Access Compliance Report

Public Rights-of-Way

(Curb Ramps)

Intersection ID: N/A	Main Street: BROOKVALE_ST	Cross Street: HORACE_ST	Location: S
ADA ID: 0DB2C53F01B8	Ramp Type: Perp	Initial Pass/Fail: Fail	Overall Compliance: No
Severity Score: 12.5			
Codes/Mitigation Info/Possible Solution		Field Measurements/Component Compliance

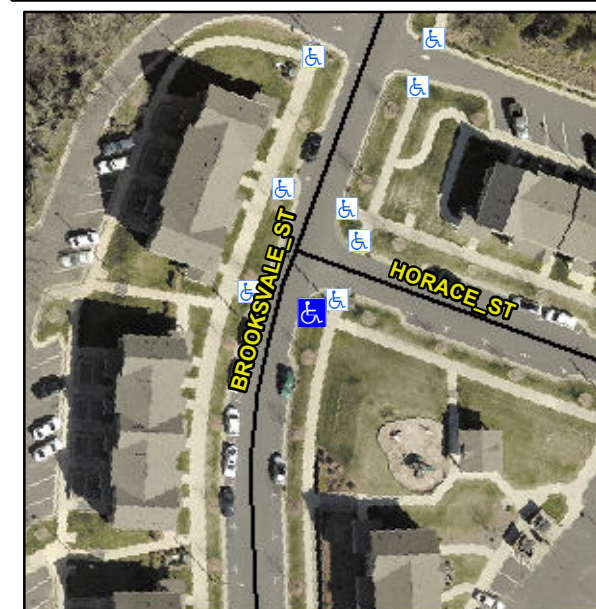
R304.2.2

Compliance	Description	Data	Compliance	Description	Data
N/A	Ramp Length (in)	71.0	No	Ramp Slope (%)	11.0
Yes	Ramp Width (in)	70.0	Yes	Ramp XSlope (%)	0.9
N/A	Flare Type LT	N/A	N/A	Flare Type RT	N/A
N/A	Flare Slope LT (%)	N/A	N/A	Flare Slope RT (%)	N/A
N/A	Flare Traversable LT?	N/A	N/A	Flare Traversable RT?	N/A
N/A	Landing Length (in)	N/A	N/A	DWS Provided?	N/A
N/A	Landing Width (in)	N/A	N/A	DWS Contrast?	N/A
N/A	Landing Slope (%)	N/A	N/A	DWS Length (in)	N/A
N/A	Landing X Slope (%)	N/A	N/A	DWS Full Width?	N/A
N/A	Landing Curb? (Y/N)	N/A	N/A	DWS Offset (in)	N/A
N/A	Shared Landing?	N/A			
N/A	Gutter Ponding?	N/A	N/A	Gutter Slope (%)	N/A
N/A	Gutter Lip Ht (in)	N/A	N/A	Gutter X Slope (%)	N/A
N/A	Painted X Walk1?	No	N/A	Painted X Walk2?	N/A
	X Walk 1 Direction	To NW		X Walk 2 Direction	N/A
N/A	X Walk 1 Width (in)	N/A	N/A	X Walk 2 Width (in)	N/A
	X Walk 1 Slope (%)	2.1		X Walk 2 Slope (%)	N/A
	X Walk 1 X Slope (%)	1.4		X Walk 2 X Slope (%)	N/A

Remove & Replace Entire Ramp.
